## ADDENDUM NO. 2 BID OPPORTUNITY NO. 15-2004

CITY OF WINNIPEG OFFICE ADDITION AND RENOVATION  
1155 PACIFIC AVENUE, WINNIPEG, MANITOBA

ISSUED: June 23, 2004  
BY: Coleen Groening /clg  
TELEPHONE NO. (204) 986-2491

Drawn By	Approved By	Reference
RC	CB	0
File No	Date	Detail Sheet
02-018-01	JUNE 2004	ED-11

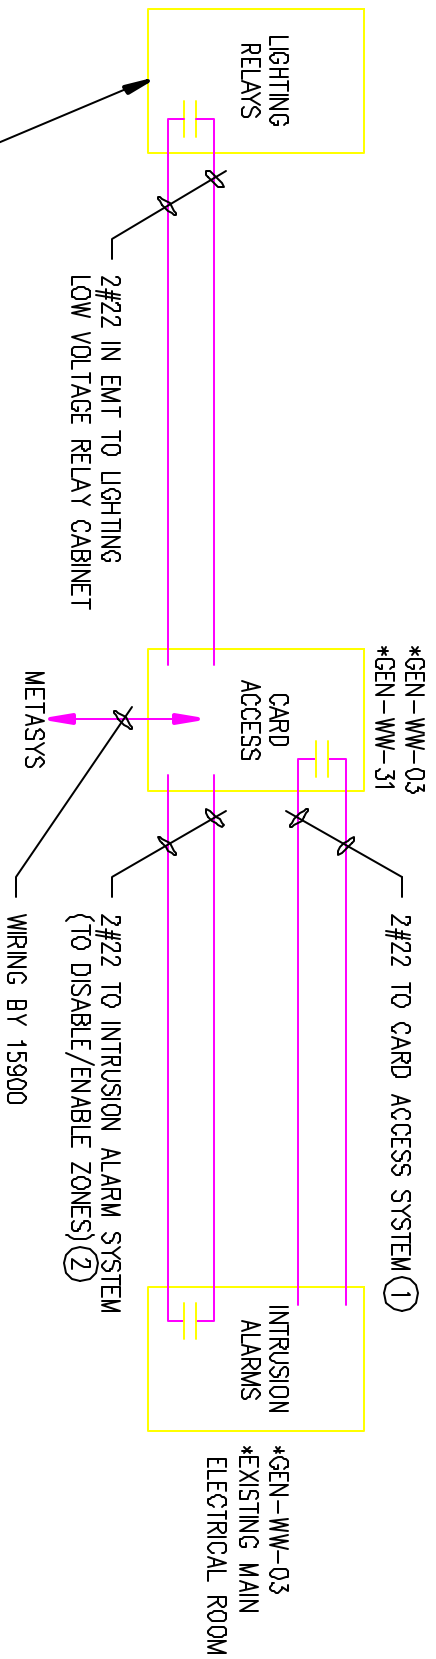
- Clause 3.1 – Installation: Add the following new paragraphs:
  - “.4 Provide multi-conductor # 22 AWG from intrusion alarm system to Johnson Metasys cabinets. Refer to detail sheet attached to this addendum.

**Add:** Detail sheet ED-11 (attached).

CARD ACCESS SYSTEM SUPPLIER TO PROVIDE 1 DRY CONTACT PER L.V. LIGHT SWITCH ON MAIN FLOOR AND PER CIRCUIT FOR "BUILDING MANAGEMENT" POINTS  
 (12 REQUIRED, 4 SPARE TO L300)  
 (10 REQUIRED, 4 SPARE TO L200)  
 (1 REQUIRED, 1 SPARE(PER PANEL)) TO PANEL 4A/4D/5A/5B/5C)  
 CARD ACCESS INPUT WILL ACTIVATE SPECIFIC RELAYS.  
 SHOP DRAWINGS WILL PROVIDE THESE DETAILS.

- ① CARD ACCESS SYSTEM SUPPLIER TO PROVIDE 1 DRY CONTACT PER 3 INTRUSION SYSTEM MOTION DETECTORS, 1 DRY CONTACT PER DOOR CONTACT IN INTRUSION SYSTEM. (NOTE: 1 DEVICE = 1 ZONE IN THE INTRUSION ALARM SYSTEM)
- ② 1 DRY CONTACT INPUT REQUIRED PER SECURITY SYSTEM ZONE TO ENABLE/DISABLE BUILDING AREA. (ALLOW FOR 20 TOTAL)
